Addendum No.2
to
CONSTRUCTION DOCUMENTS
for

June 2, 2025
2023159.00

NCISD New District Administration Building
21330 Valley Ranch Parkway
New Caney, TX. 77357
June 2, 2025

T-105-C1

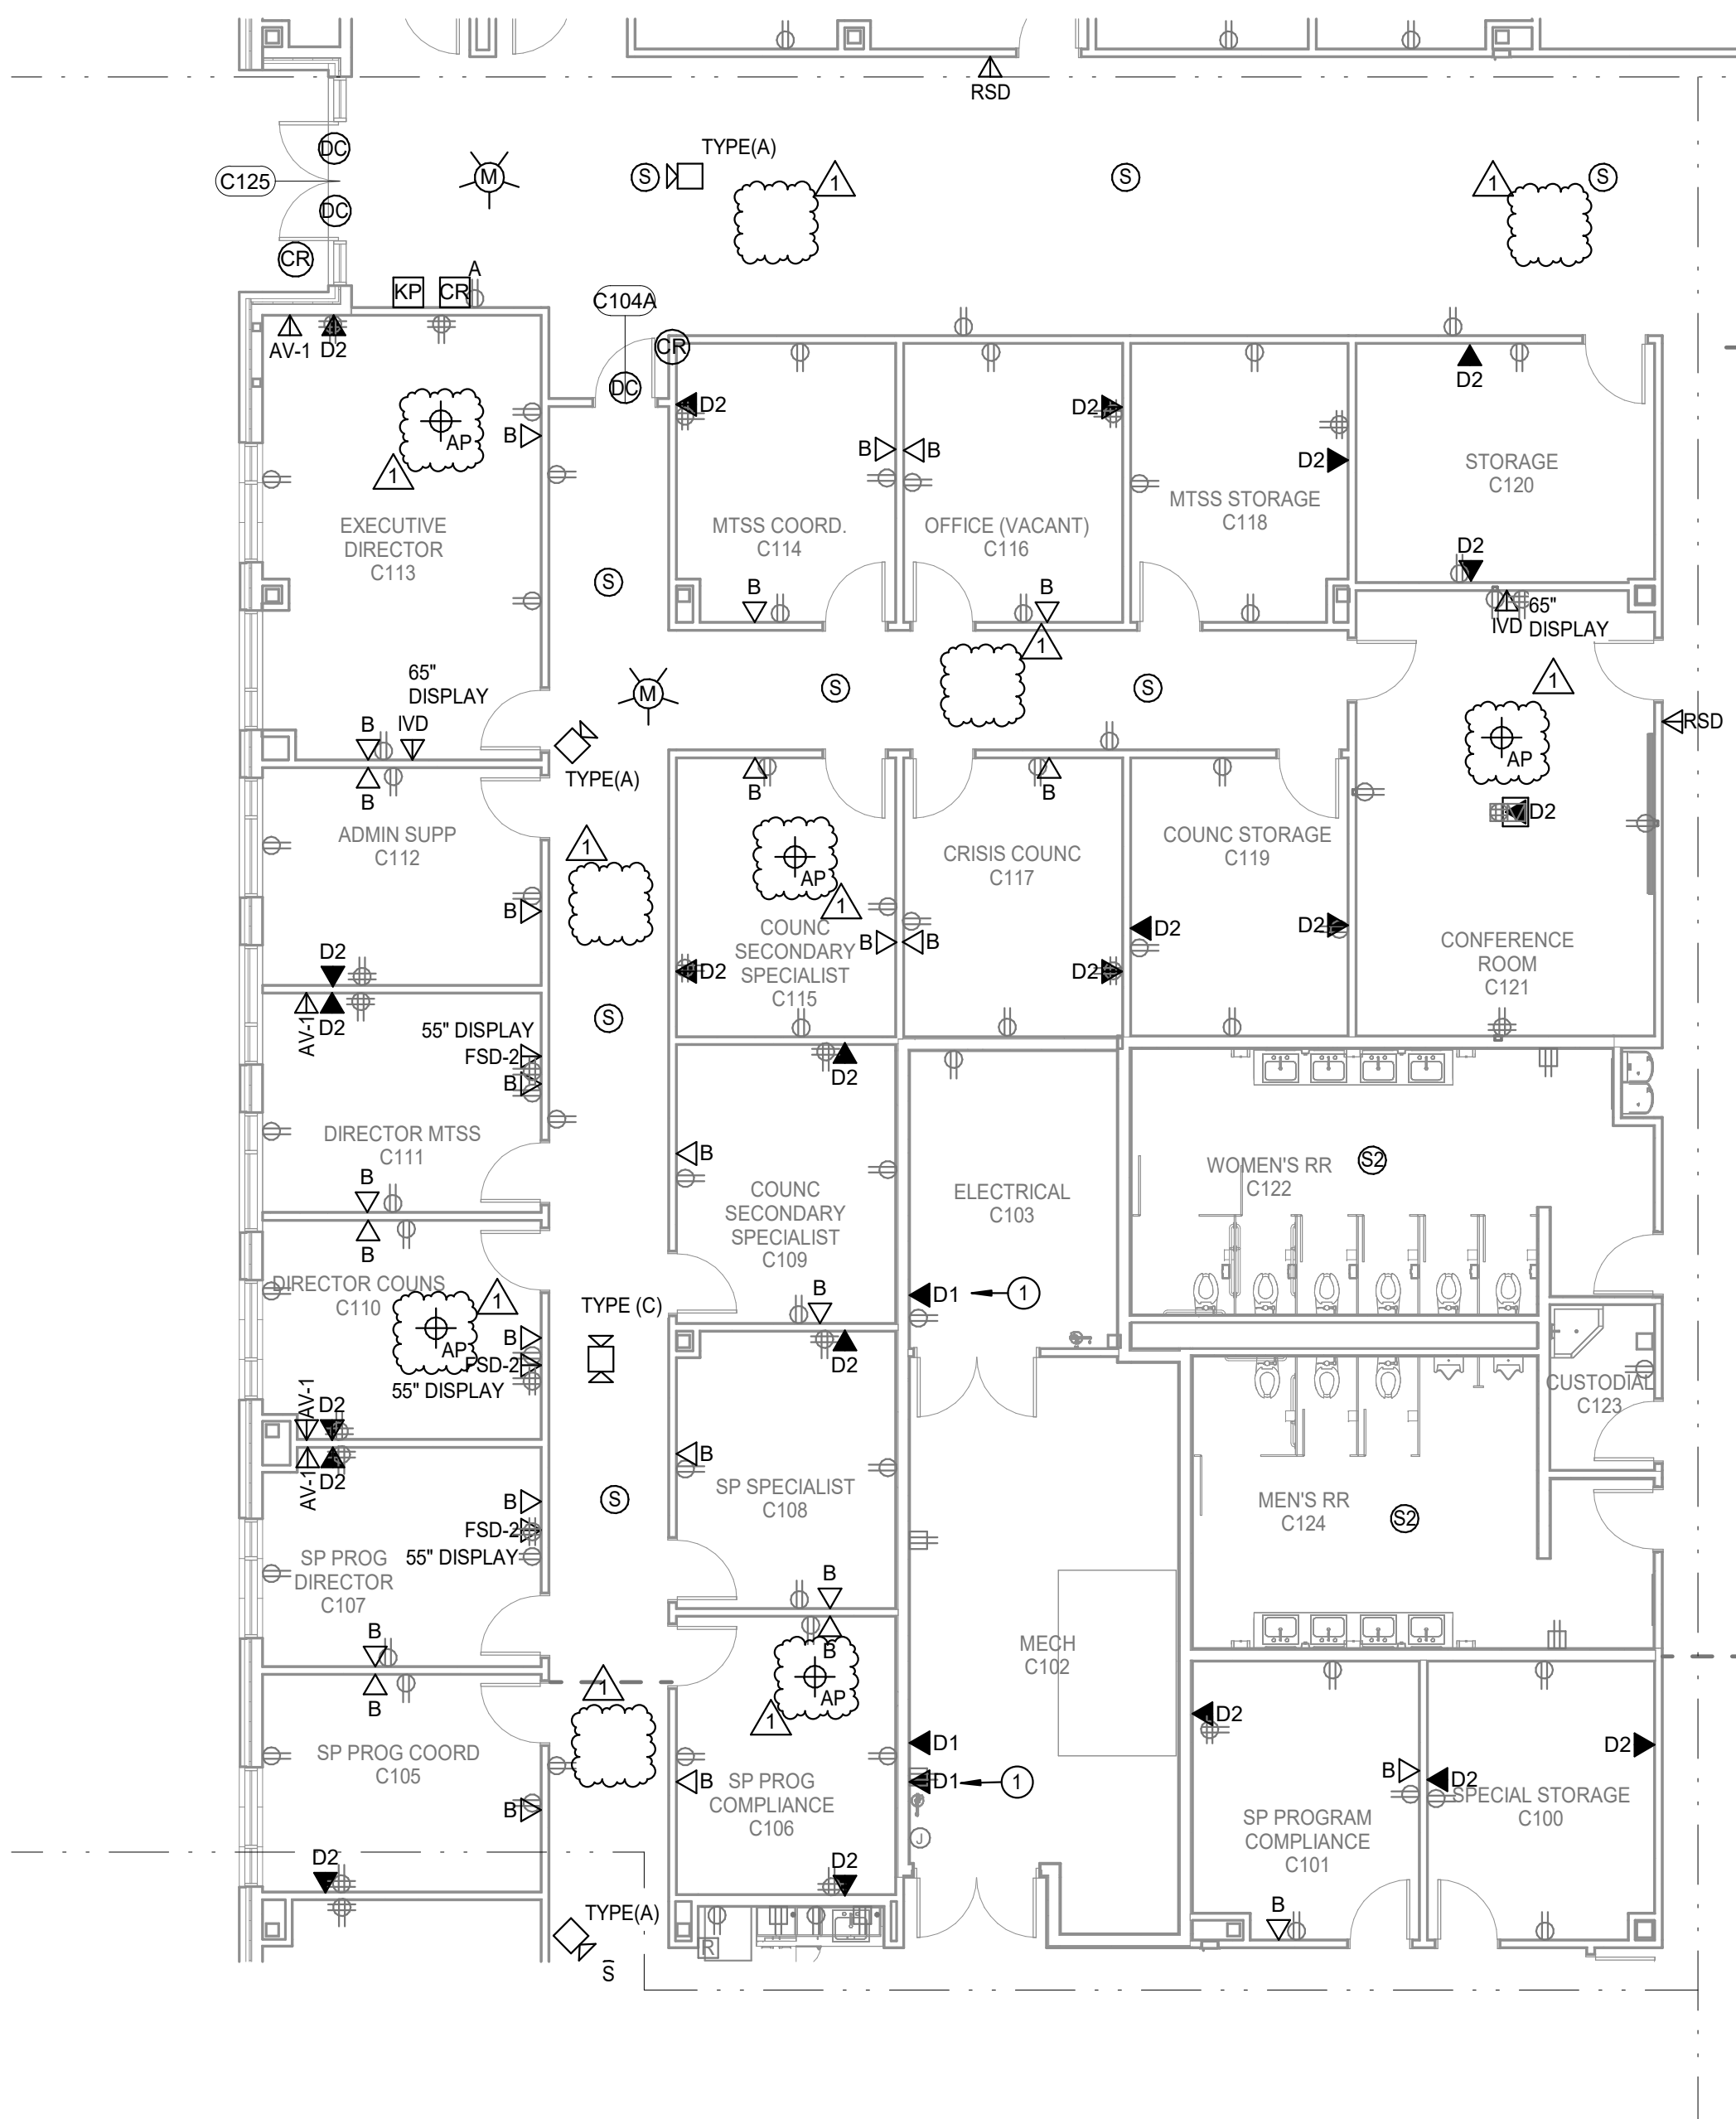
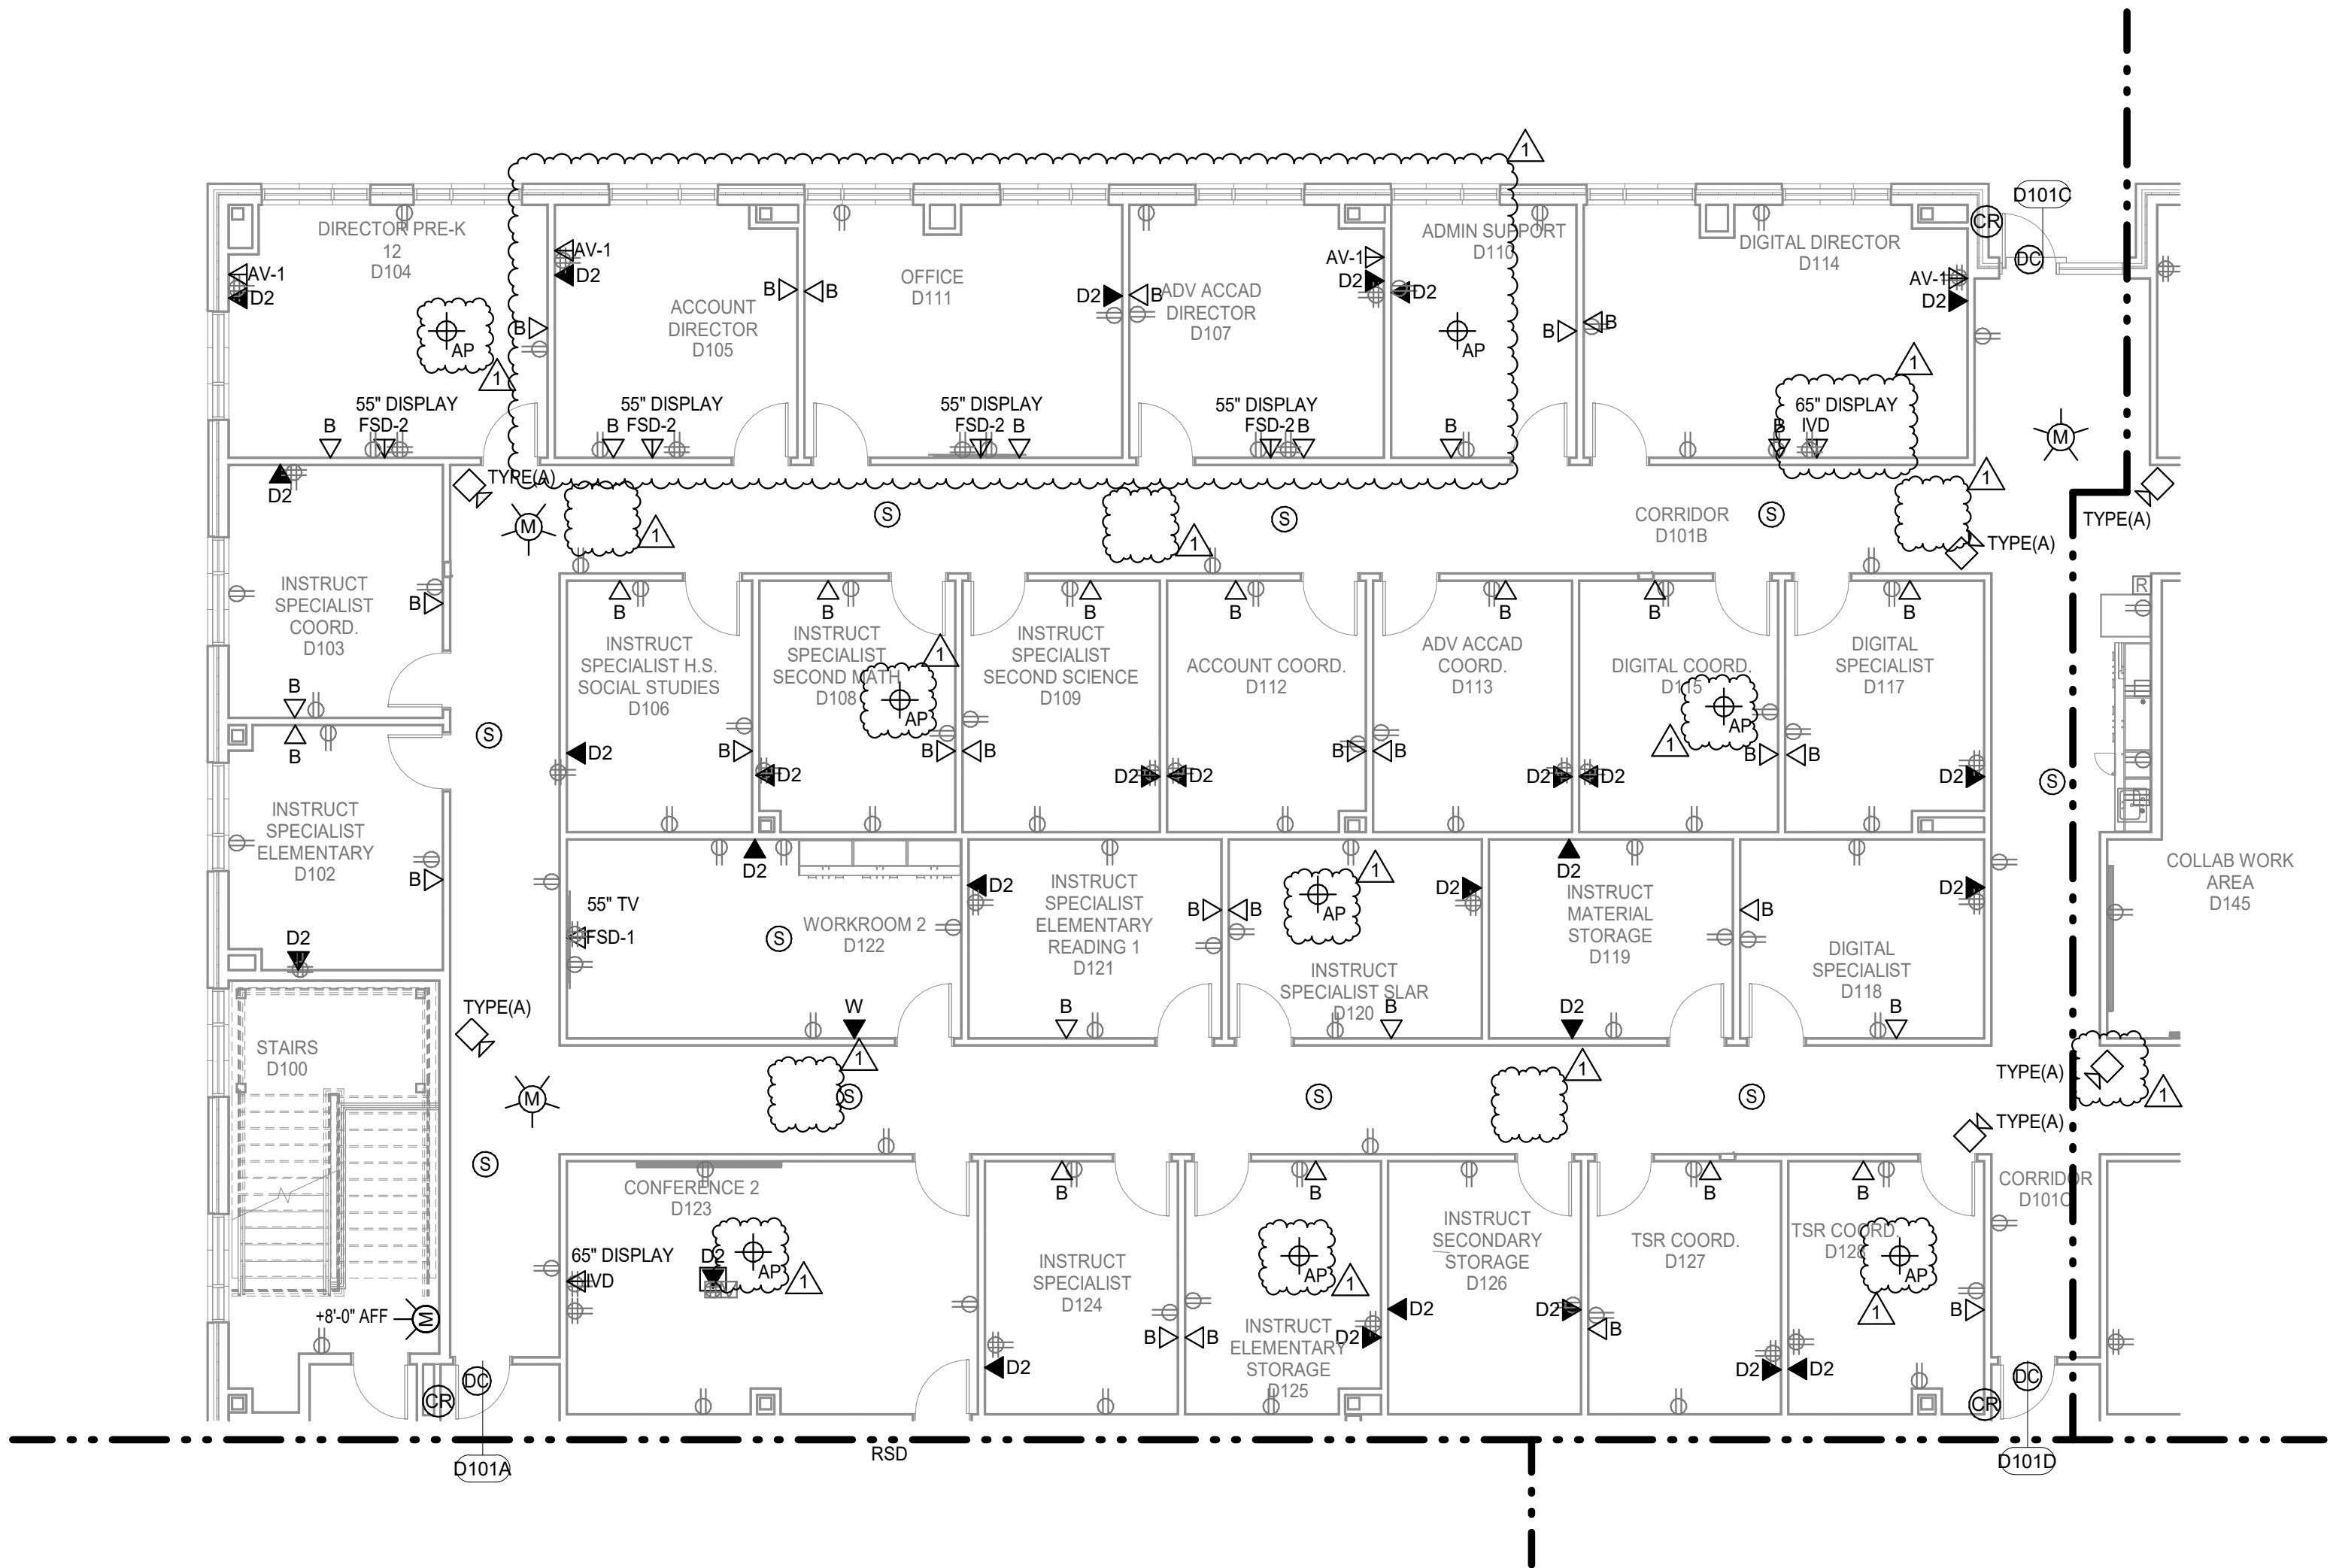
- a. Revised wireless access point 'AP' layout as shown.
 - 15. SHEET T-106-D1 - TECHNOLOGY FIRST FLOOR AREA - D1
 - a. Revised wireless access point 'AP' layout as shown.

T-110-G1

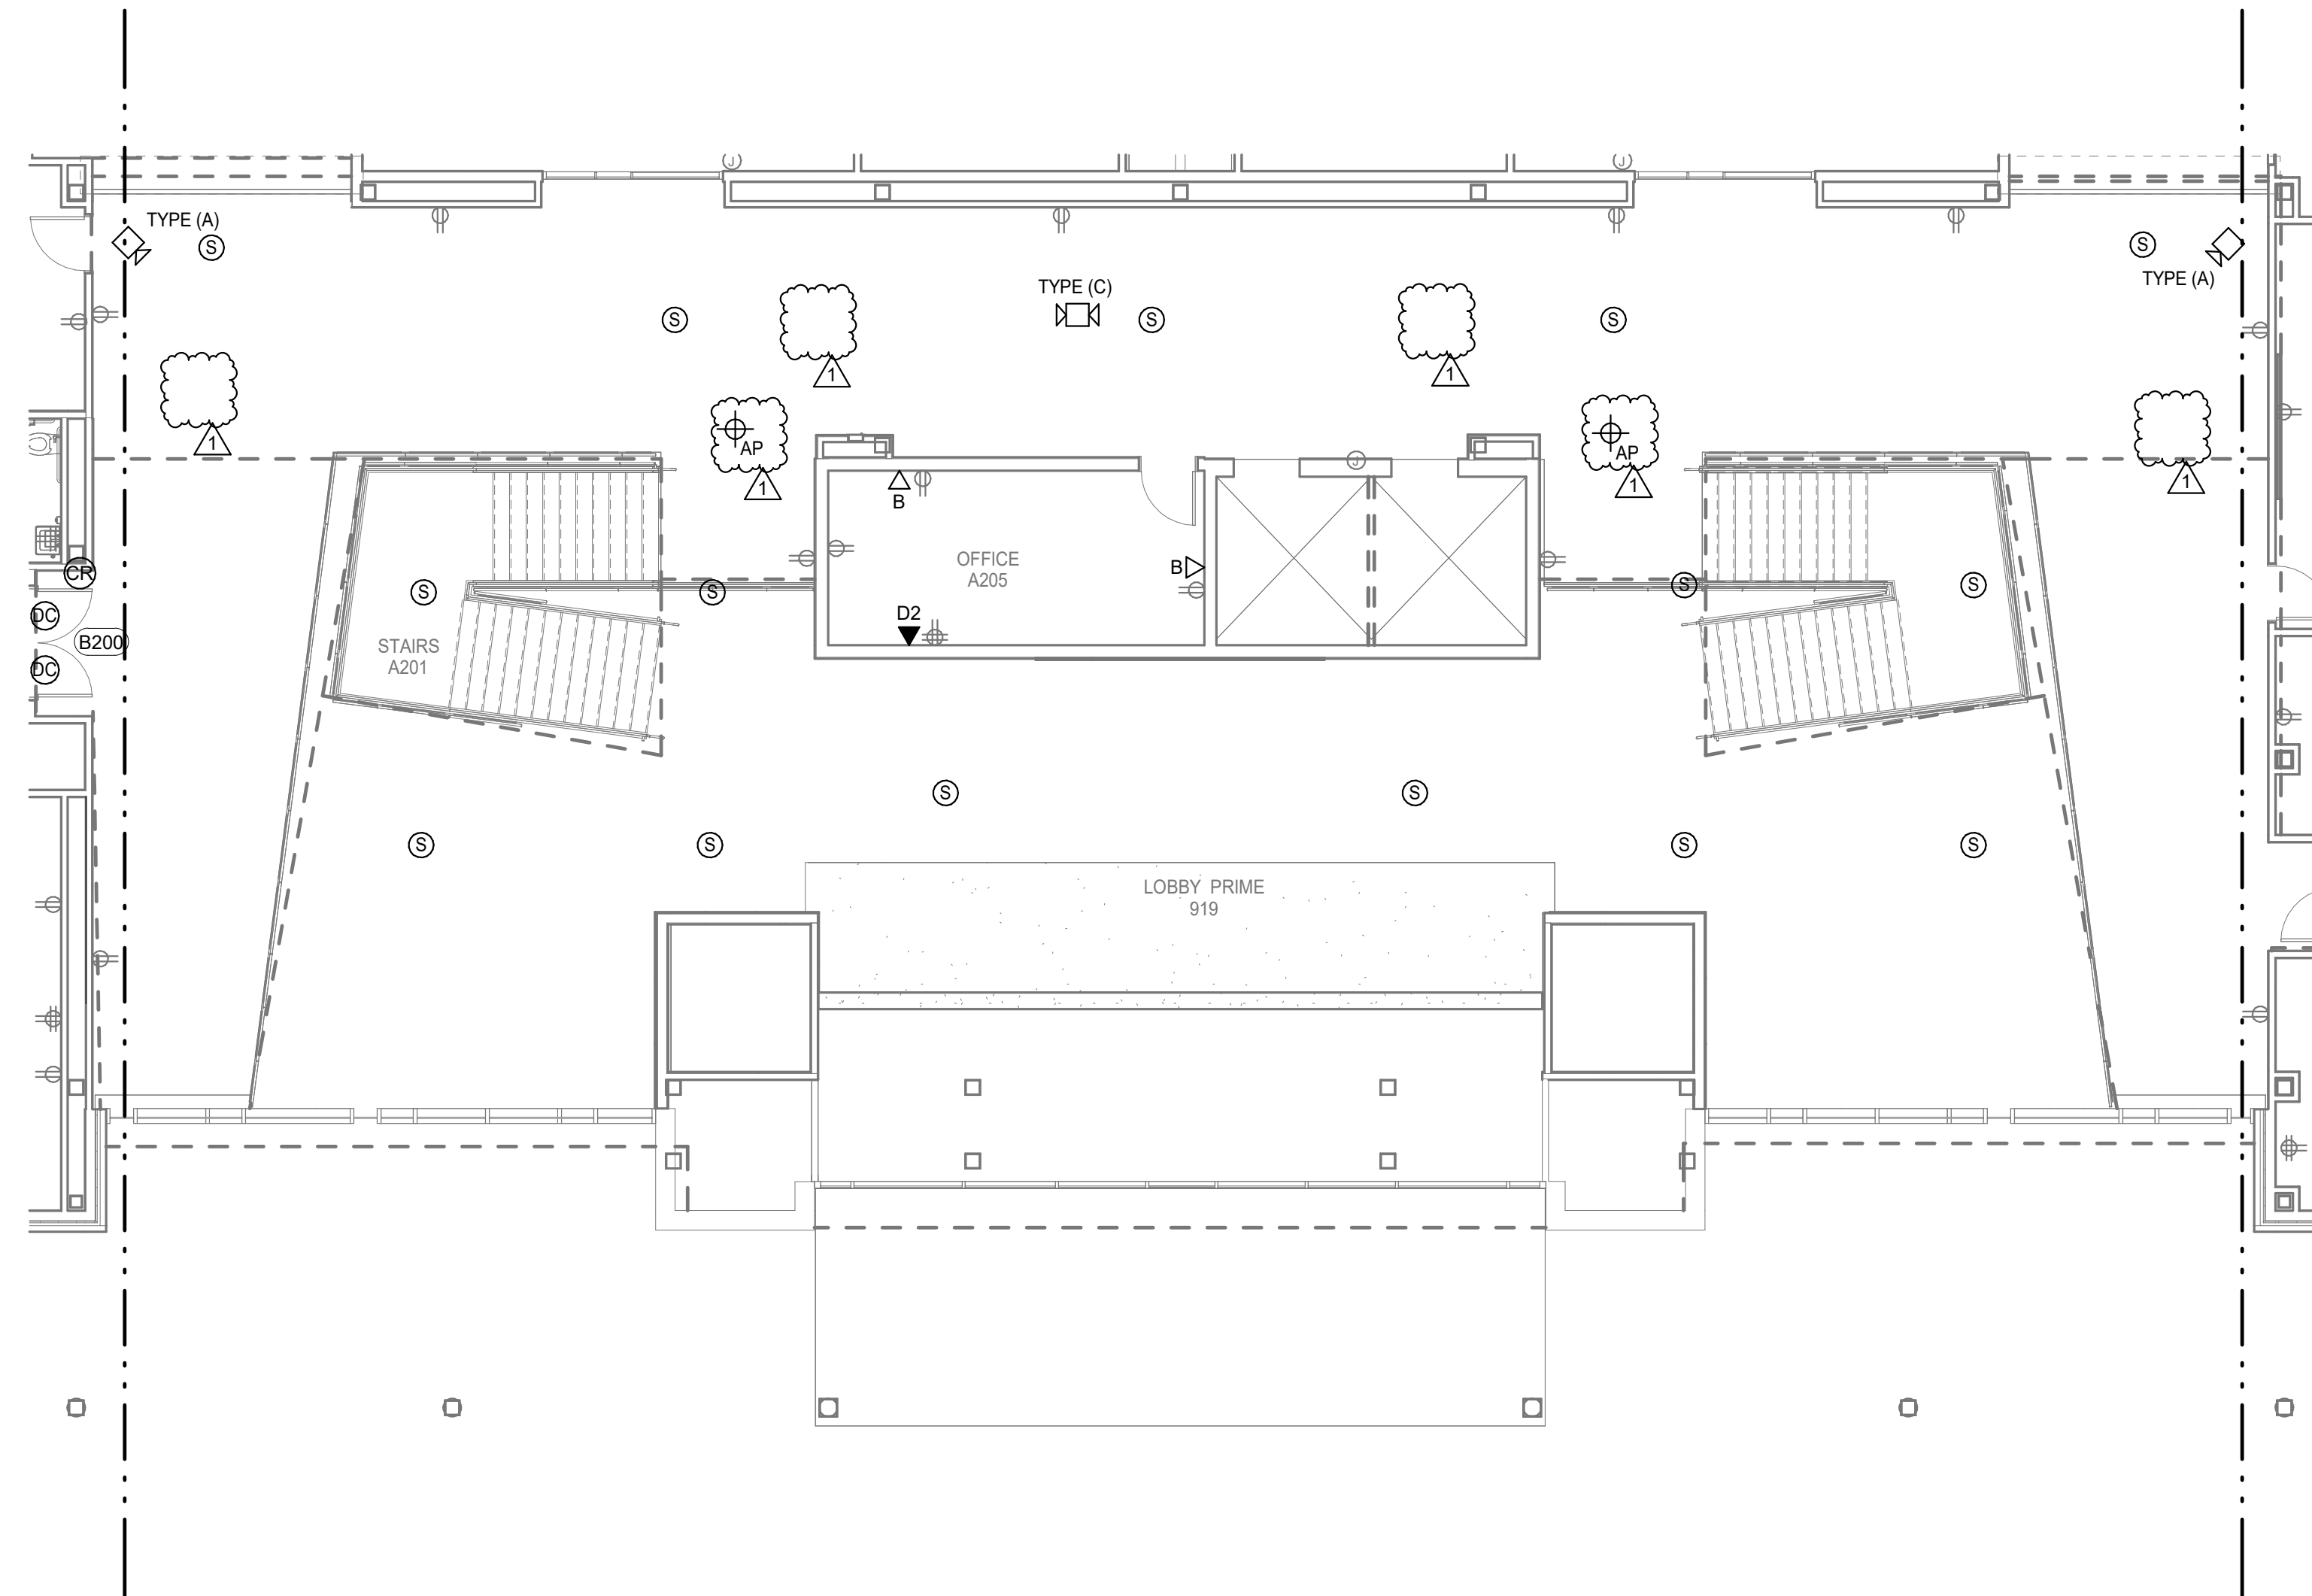
- a. Revised wireless access point 'AP' layout as shown.
 - b. Added (1) dual lens camera as shown.
 - 20. SHEET T-111-A2 - TECHNOLOGY SECOND FLOOR AREA - A2
